Work Order ID 158531

Item Name: Frame

DRAWING NO. D3290	TITLE REPLACEMENT WINDOW ASSEMBLY	REV. C	DART AEROSPACE LTD ENGINEERING ORDER		D.E.O. NO. D3290-C-1	SHEET NO. SHEET 1 OF 1	SCALE NTS
DRAWN <i>qp</i>	CHECKED <i>ib</i>	MFG. APPR. <i>EZ</i>	APPROVED <i>MP</i>		DE APPR. <i>MP</i>		
DATE 09.09.18	DATE 09.09.18	DATE 09.09.18	DATE 09/09/21		DATE 09/09/21

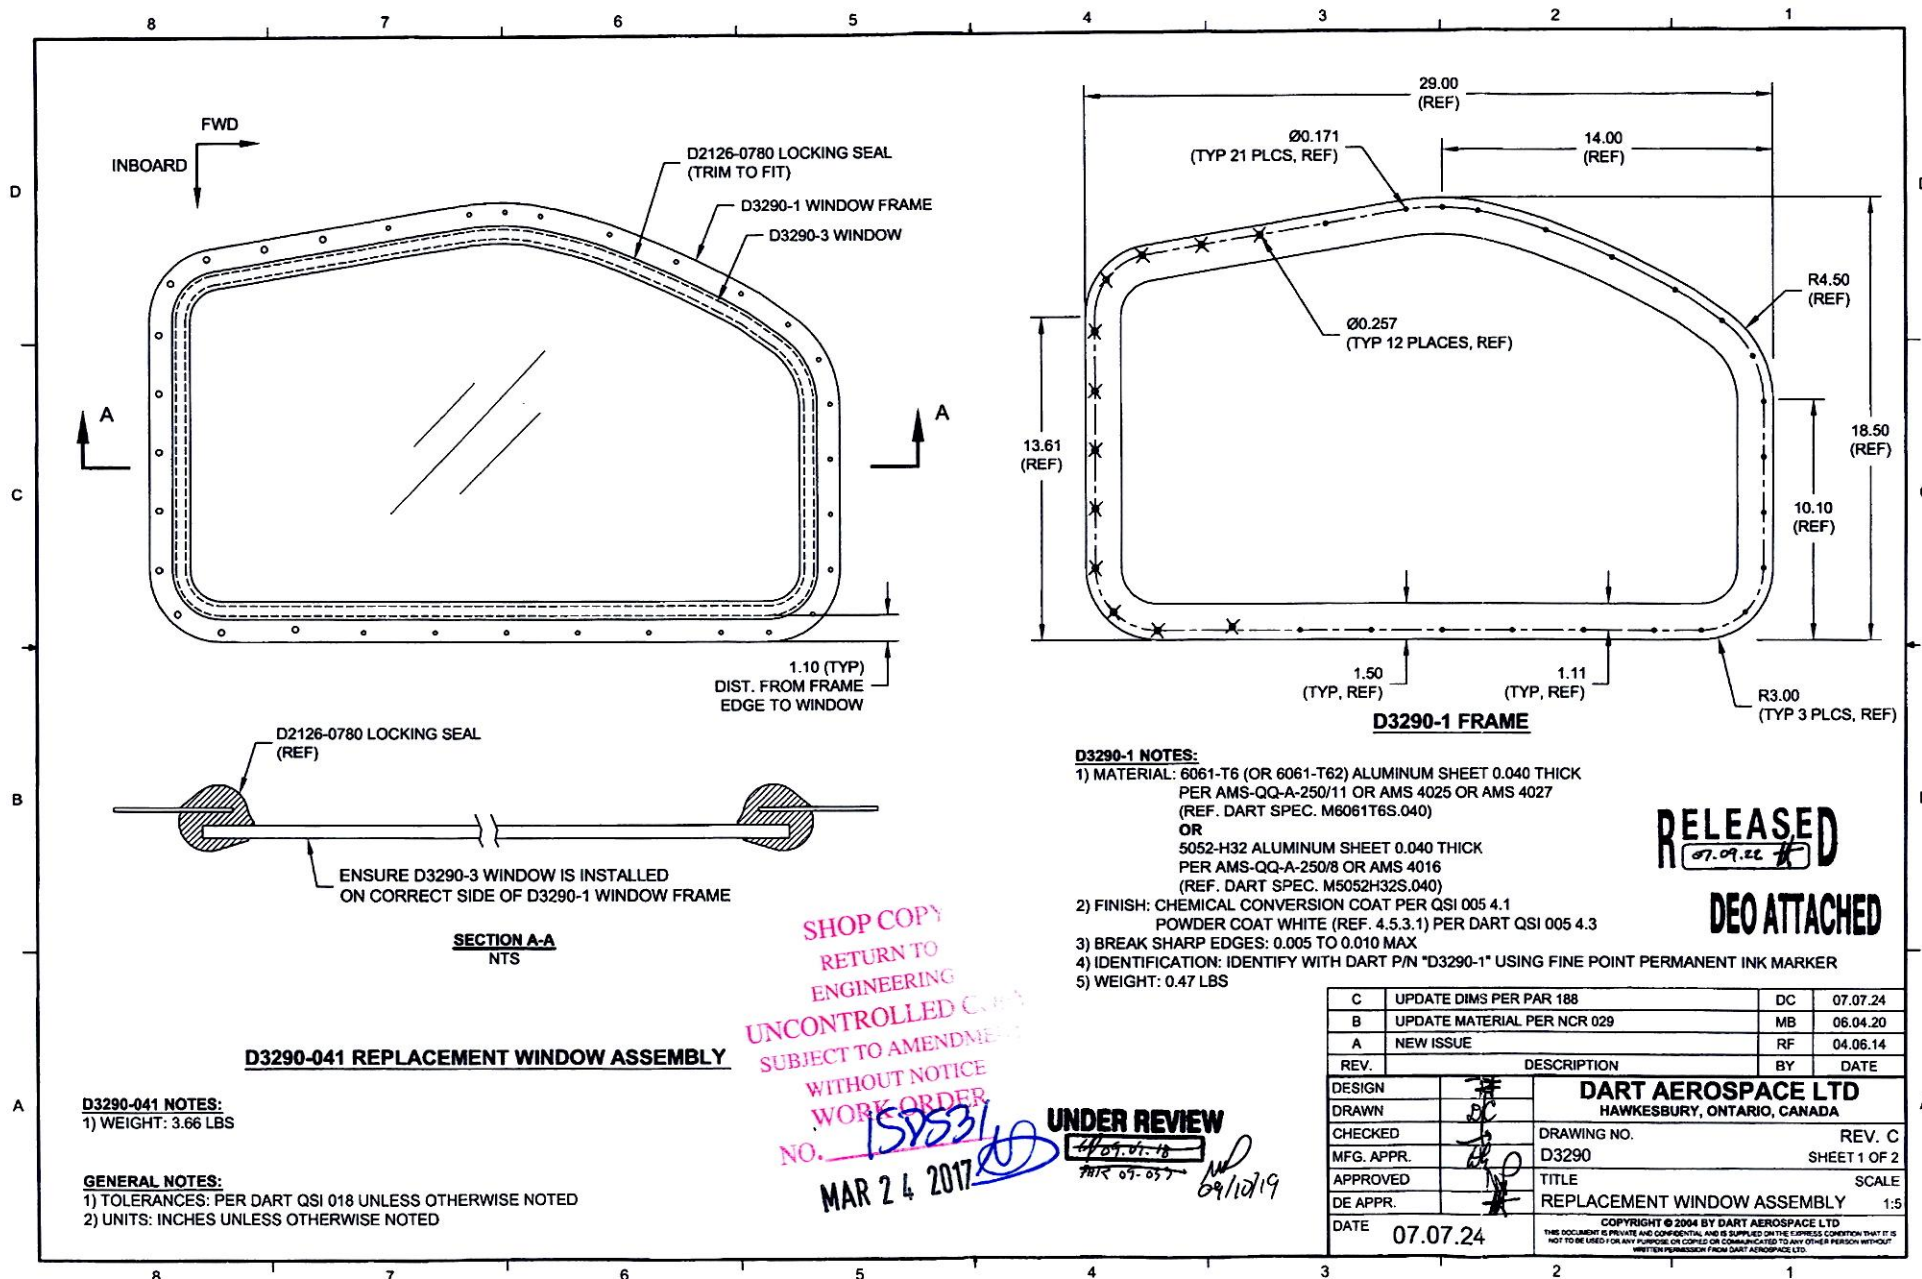
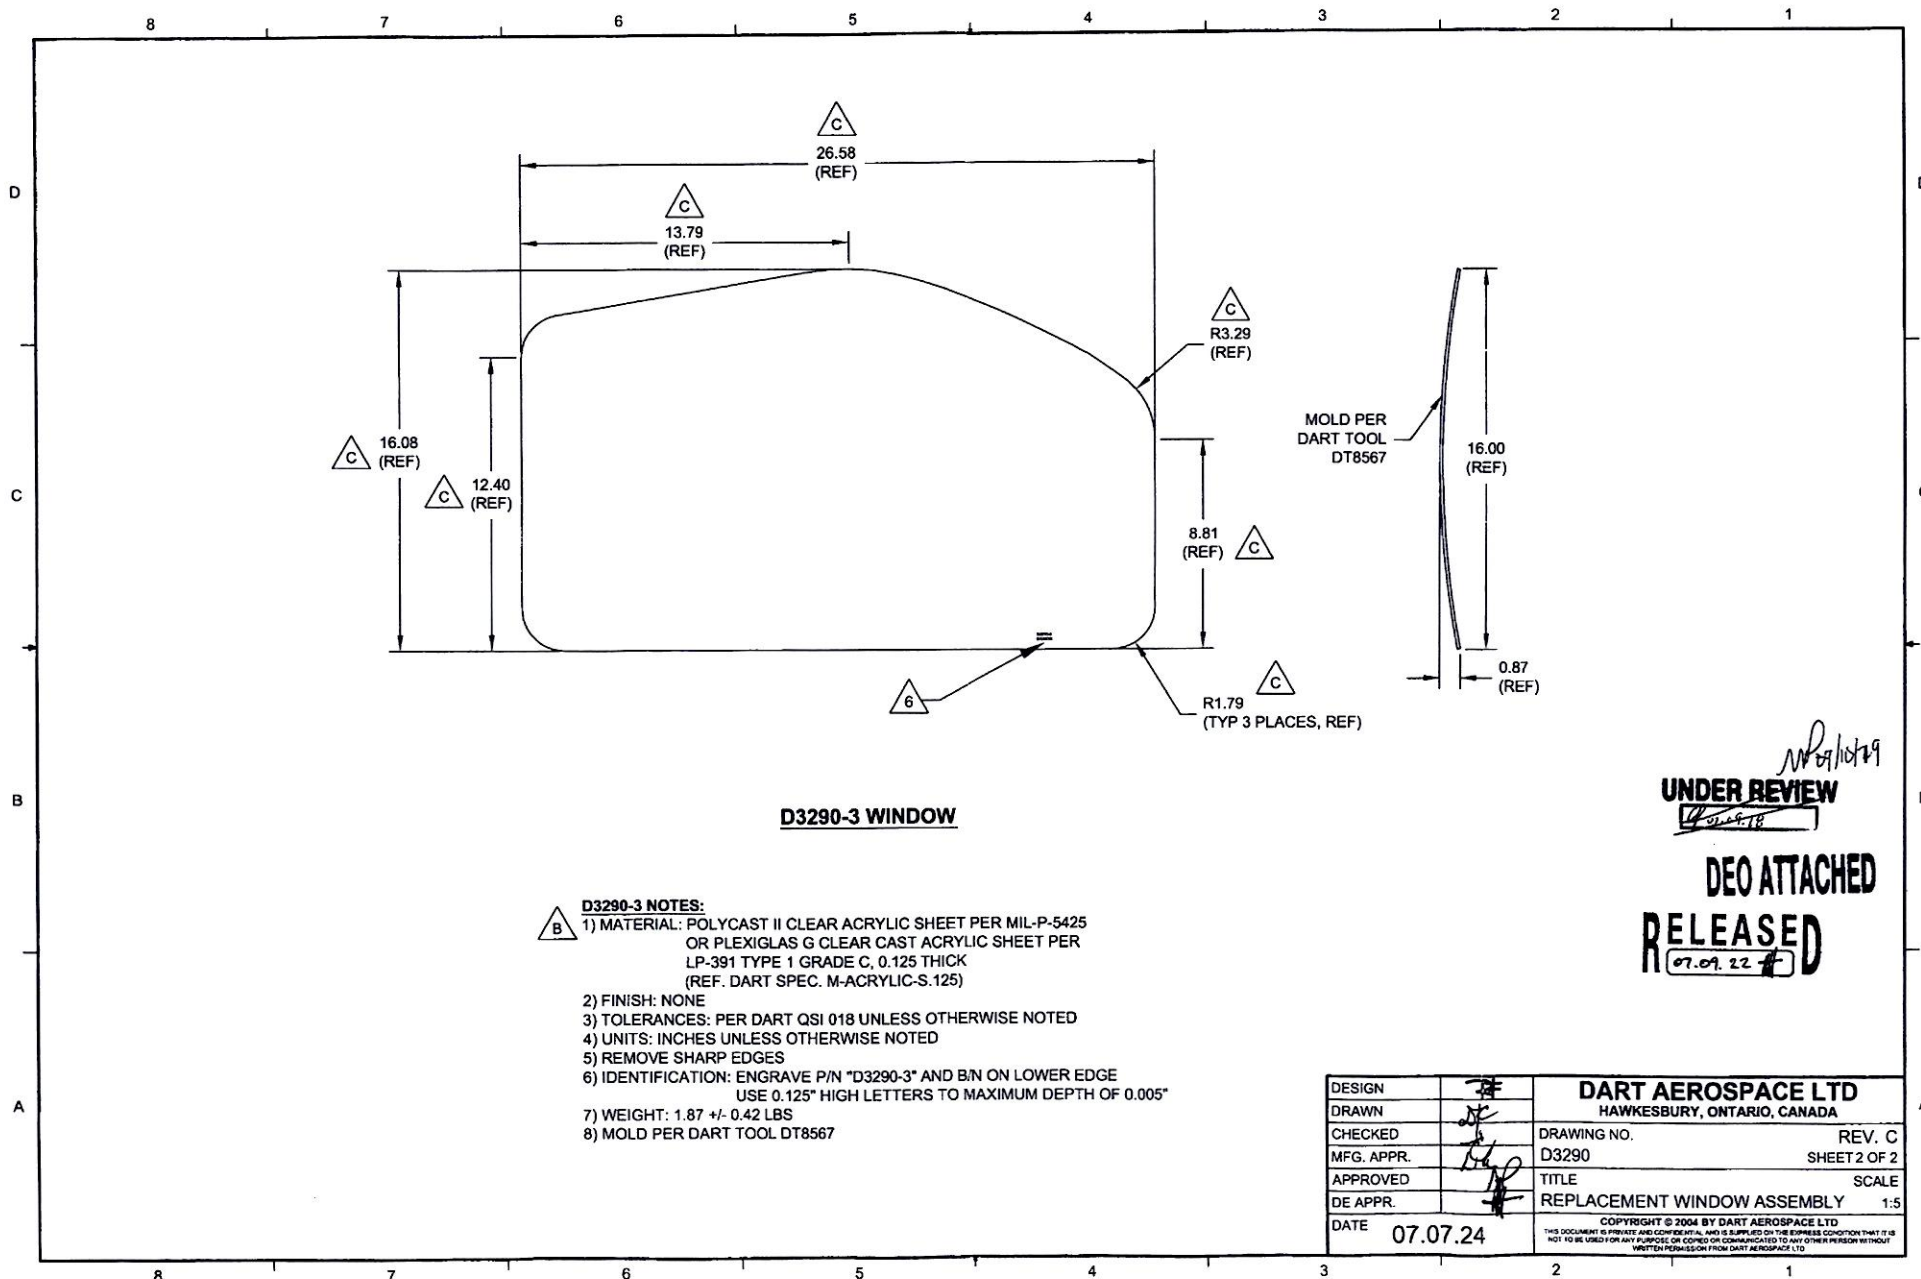
CHANGE MATERIAL THICKNESS OF D3290-1 FRAME TO 0.063 FROM 0.040. REF PAR 09-033.

MATERIAL CALL-OUT OF D3290-1 FRAME ON SHEET 1 IS AMENDED AS FOLLOWS:

- 1) MATERIAL: 6061-T6 (OR 6061-T62) ALUMINUM SHEET ~~0.040 THICK~~ 0.063 THICK (REPLACE)
 PER AMS-QQ-A-250/11 OR AMS 4025 OR AMS 4027
~~(REF. DART SPEC. M6061T6S.040)~~ REF. DART SPEC. M6061T6S.063 (REPLACE)
 OR
 5052-H32 ALUMINUM SHEET ~~0.040 THICK~~ 0.063 THICK (REPLACE)
 PER AMS-QQ-A-250/8 OR AMS 4016
~~(REF. DART SPEC. M5052H32S.040)~~ REF. DART SPEC. M5052H32S.063 (REPLACE)
